**Official Transcript of Proceedings**  
**NUCLEAR REGULATORY COMMISSION**

Title: Advisory Committee on Reactor Safeguards  
608th Meeting

Date: Wednesday, October 2, 2013

**Figure VII-1**  
**One of the Pool Layouts Modeled in NRC's Draft Consequence Study: The OCP2, High-Density, 1x4 Case**

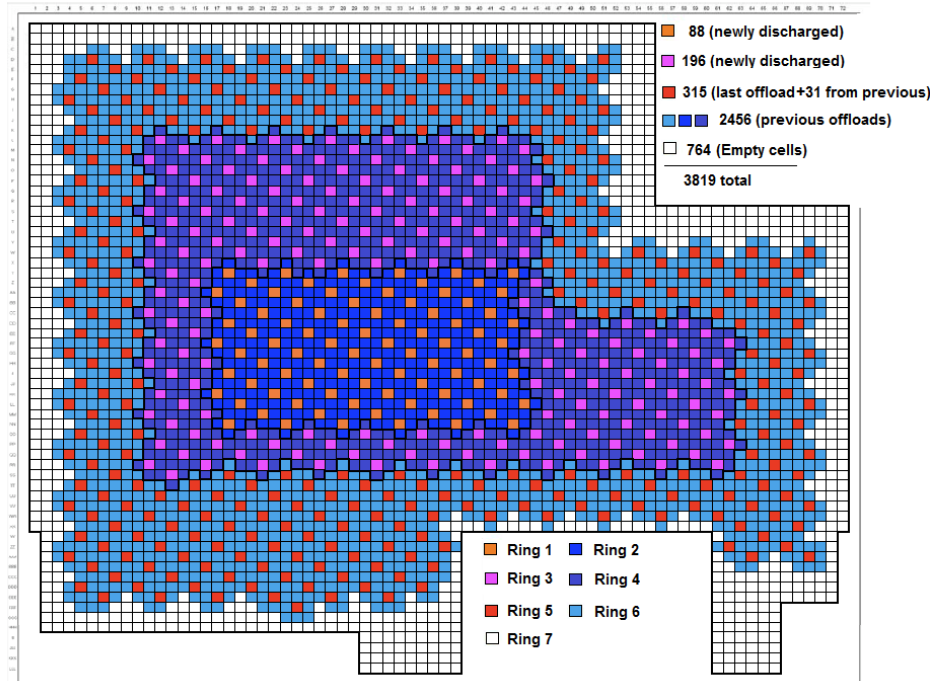
(VII-5) In addition to questions about the validity of MELCOR, there are questions about NRC's input assumptions. For example, how closely does the pool layout shown in Figure VII-1 correspond with actual practice in the nuclear industry? In that context, there is a puzzling NRC assumption associated with Figure VII-1. That figure shows a total of 284 newly-discharged fuel assemblies. Of these, 88 assemblies are assumed by NRC to produce decay heat at the rate of 10.9 kW per assembly when aged 20 days, while the remaining 196 assemblies produce 6.6 kW per assembly at the same age.<sup>47</sup> If this is typical practice, then licensees are forgoing substantial available burnup of the

majority of their fuel assemblies, with a resulting economic penalty.<sup>48</sup> As a related matter, Figure VII-1 shows a rather elaborate layout of fuel, whose achievement would involve substantial shuffling of assemblies. NRC says that this layout is comparatively favorable in terms of the risk of a pool fire. Yet, licensees are allowed a period of time, during and perhaps after a refueling outage, to perform the shuffling needed to achieve a favorable layout. The length of that period of time is a secret because, NRC says, this information could be useful to an adversary.<sup>49</sup> Thus, is it appropriate to assume, as a MELCOR input, that a comparatively favorable layout has been achieved before water is lost?

**Figure VII-2**  
**Findings from NRC's Draft Consequence Study: Water Level and Ring 1 Cladding Temperature for Unmitigated High-Density Moderate Leak (OCP4)**

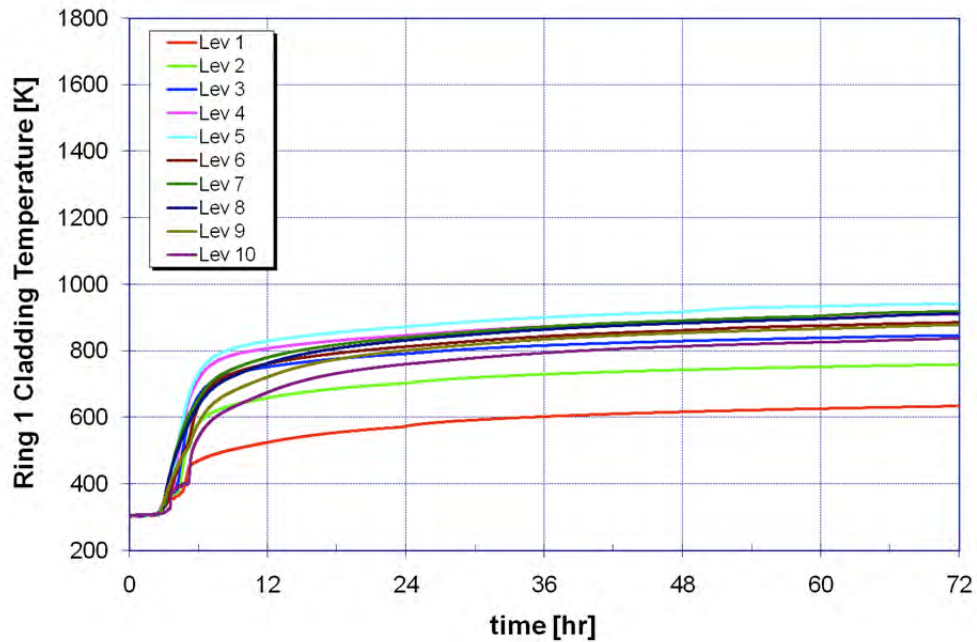
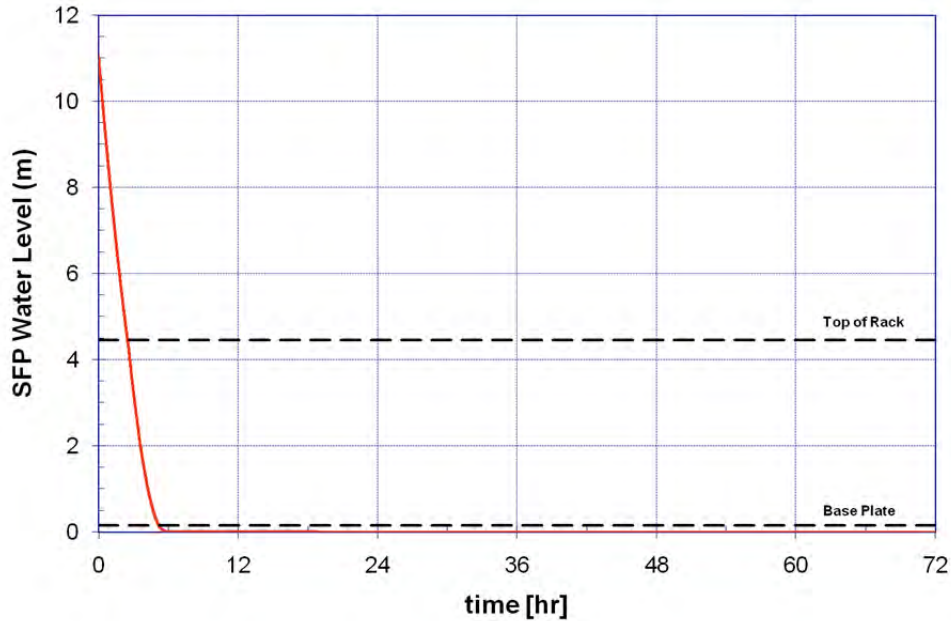
(VII-10) Now, consider MELCOR outputs for NRC's examination of a moderate-leakage case in OCP4, as shown in Figure VII-2. During the evolution of this case, there would be a period of time when the upper portion of the fuel is exposed and residual water is present. That period would extend from about  $t = 3$  hours to about  $t = 6$  hours. During that 3-hour period, at the "Lev 5" elevation of the fuel, cladding temperature would rise from about 300 K to about 700 K. Thus, the average rate of temperature rise would be about 130 K per hour. This finding indicates that the exposed portion of the fuel at the Lev 5 elevation would be in an approximately adiabatic situation, at least for temperatures up to 700 K.

**Figure VII-3**  
**Findings from NRC's Draft Consequence Study: Water Level and Ring 1 Cladding Temperature for Unmitigated High-Density Small Leak (OCP4)**

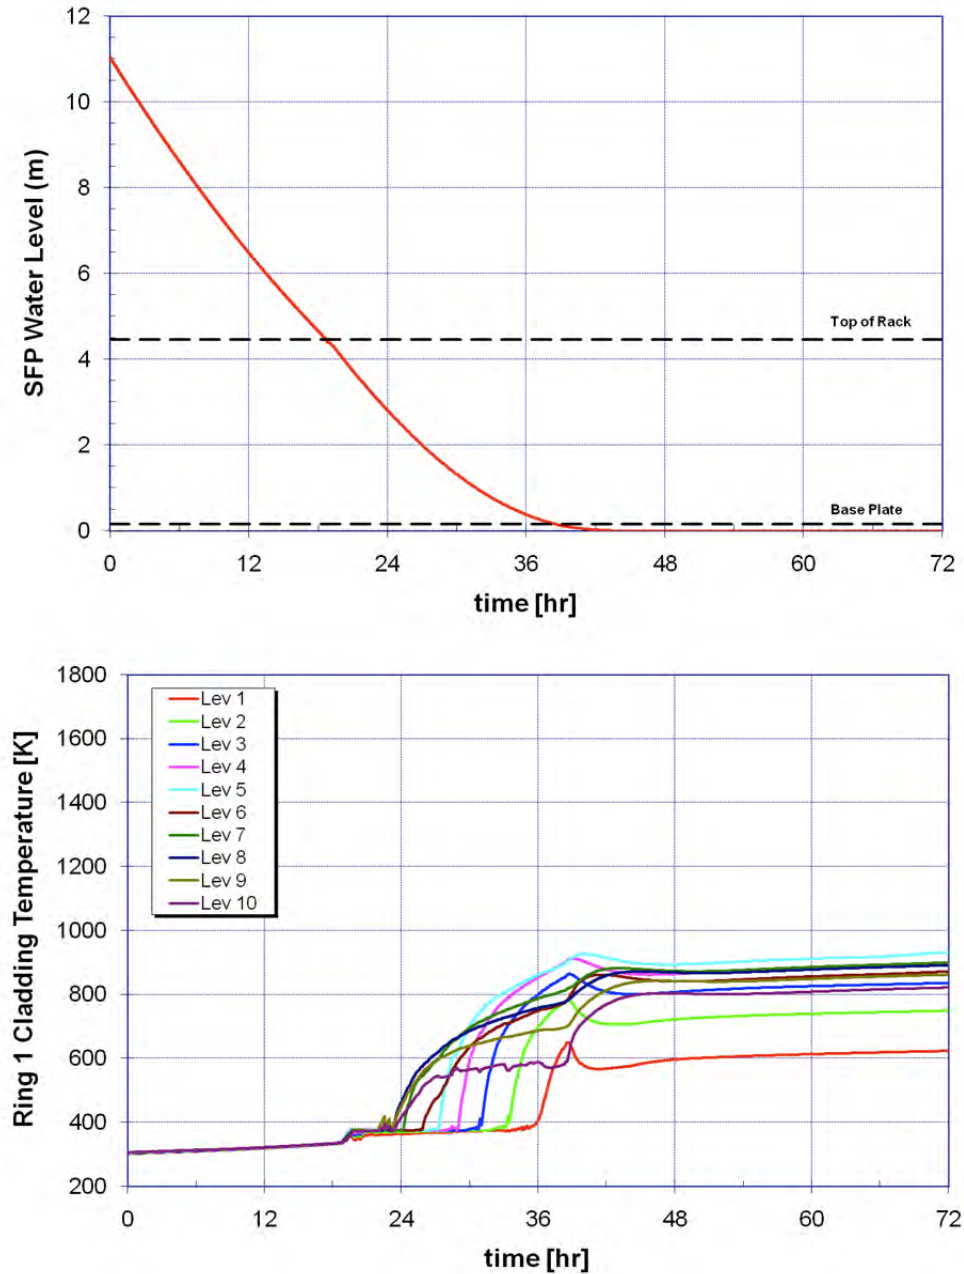
(VII-11) Now, apply the same process, as in the preceding paragraph, to NRC's examination of a small-leakage case as shown in Figure VII-3. In that case, the period of time when fuel at the Lev 5 elevation is exposed and residual water is present would extend from about  $t = 28$  hours to about  $t = 40$  hours. During that 12-hour period, the temperature of fuel cladding at the Lev 5 elevation would rise from about 350 K to about 900 K. Thus, the average rate of temperature rise would be about 46 K per hour.
